Department of Environmental Quality

RE: Permit 218C, 2006-2007 Annual Report review, Second Round Comments

RE: 2007 Annual Report. Review of the operator responses to the LQD's First Round Comments sent 4/21/2008.

Figure 3. Highland Pit Lake Water Quality Data

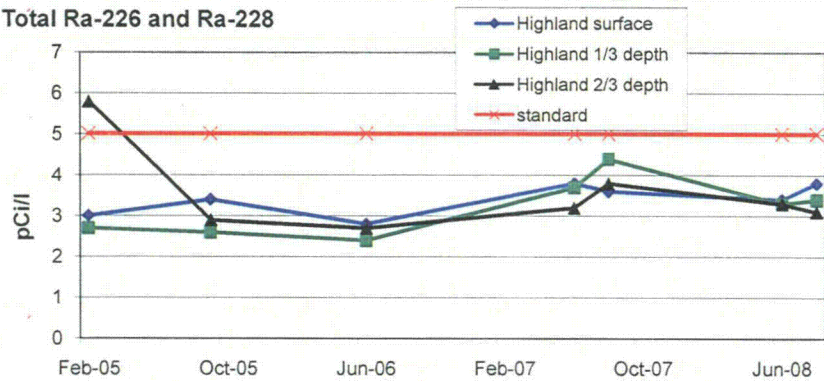
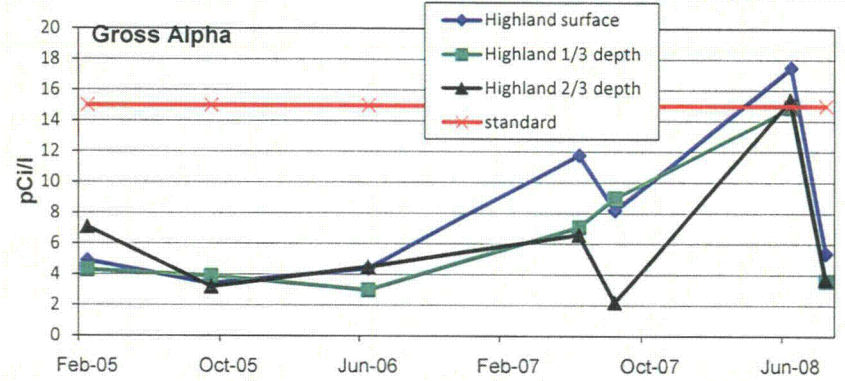
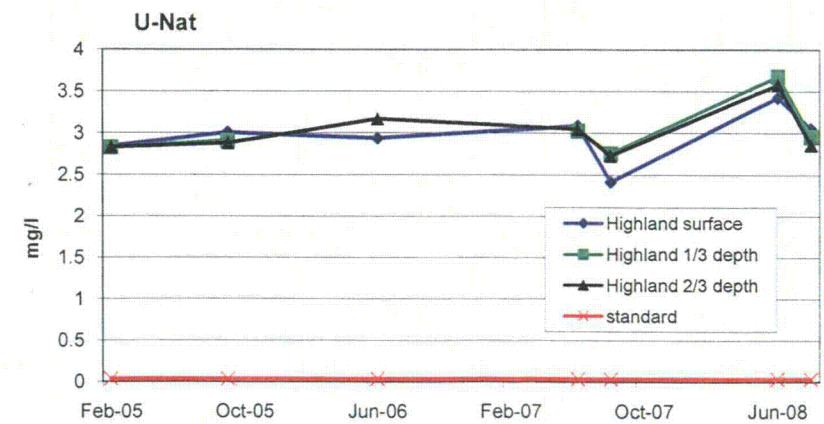
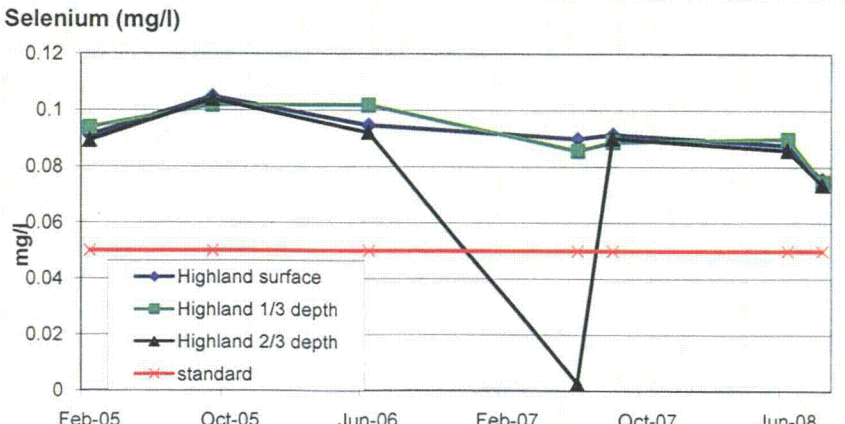
Comment 2.2. Response conditionally accepted.

The 2006 results from the Pit Lake were attached. However, the concentration of U-Nat. at the 1/3 depth (sample No. 168) collected on 6/23/2006 is 319 m/l. Please verify if this is the typo error. The summary of the results is included in **Figure 3**.
